# BID ADDENDUM NO. 1

City of Auburn, Maine  
Fish Hatchery Road Culvert Replacement  
January 31, 2022

FISH HATCHERY ROAD  
CULVERT REPLACEMENT

**C-006**

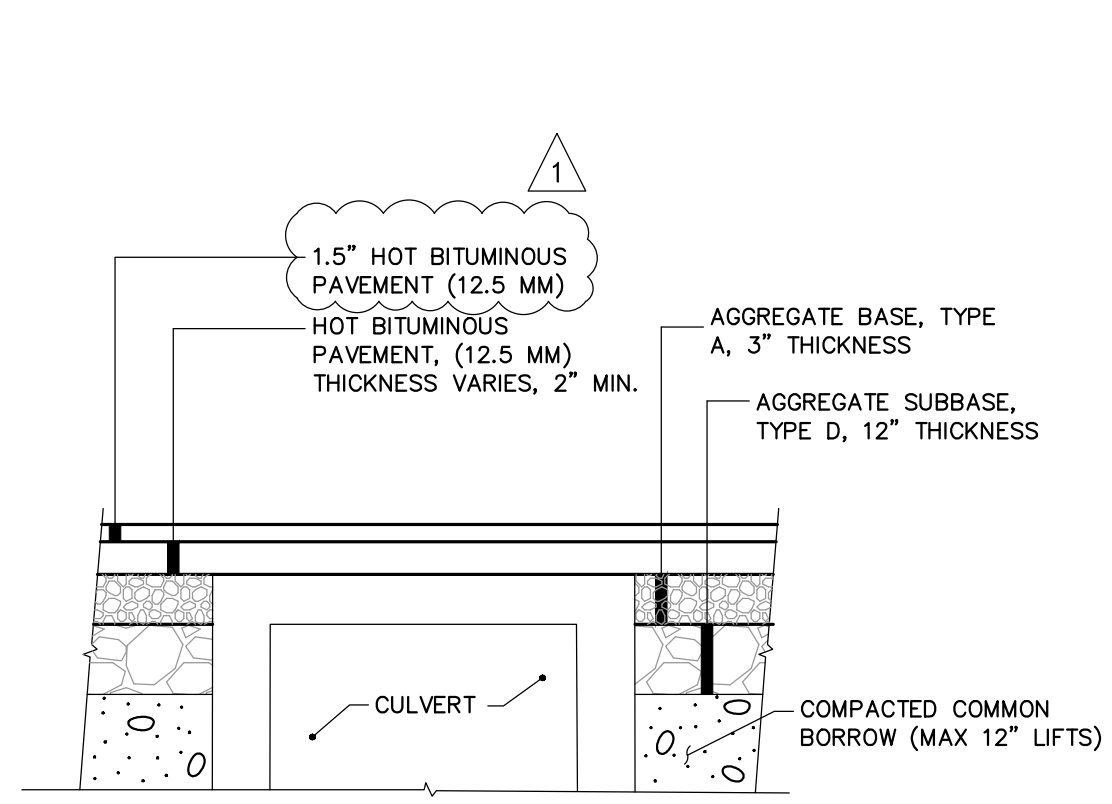
3. Do you have a specified membrane waterproofing per Box Culvert Note #2 on plan sheet C-006?  
Answer: Refer to the Maine DOT's Qualified Products List for acceptable waterproofing membrane products.

**BITUMINOUS PAVEMENT SECTION (OVER CULVERT)**  
N.T.S.

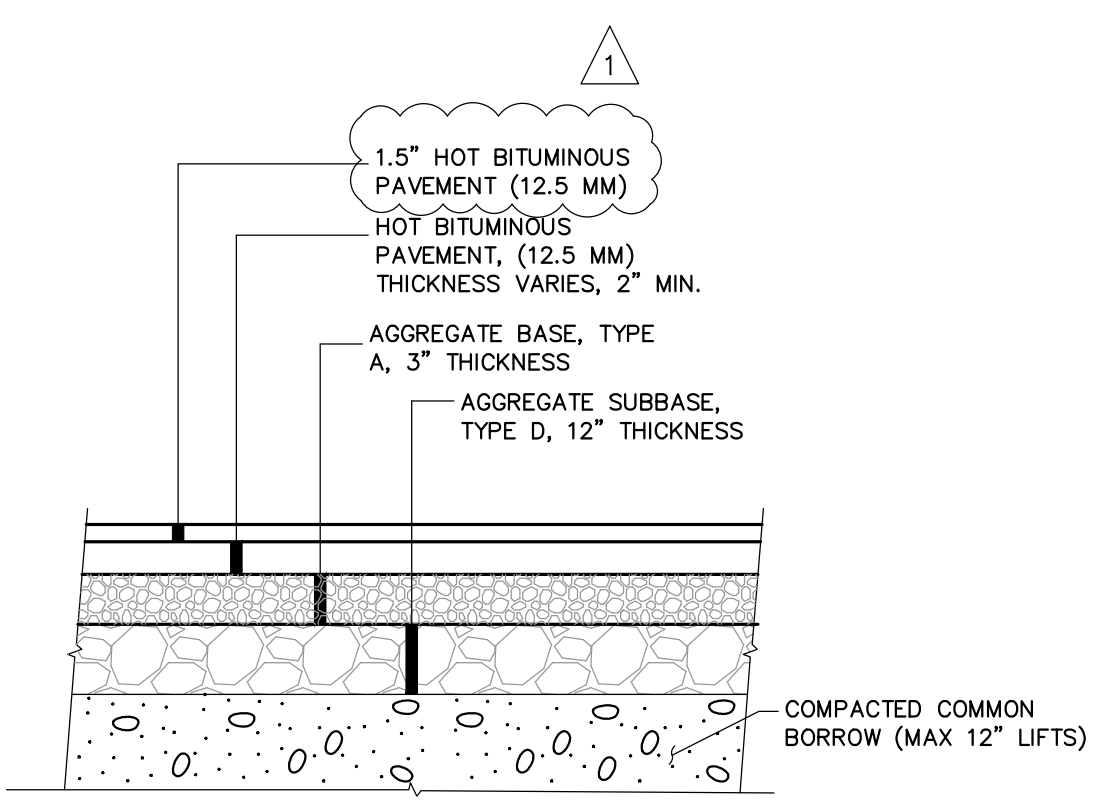
6. Just looking for some clarification on exactly what the road treatment should be over the box culvert. Are we still looking for 3" of HMA like the rest of the road or greater? The profile on page C-003 makes me think otherwise.  
Answer: A minimum 2.0" base course followed by 1.5" surface course is required over the box culvert. Base course shall be thicker as required to provide minimum slopes over the box. Please refer to the re-issued Sheet C-006 for revision to the surface course thickness.

8. The plans show 2" of 12.5mm and 1" 12.5mm surface. Can you verify with the City the type of mix and thickness. 12.5mm surface cannot be put down 1" thick, we typically use 1.5" min. with 12.5mm. Please advise on this.  
Answer: Please refer to the re-issued Sheet C-006 for revision to the surface course thickness, specifying 1.5" thick 12.5mm surface course.
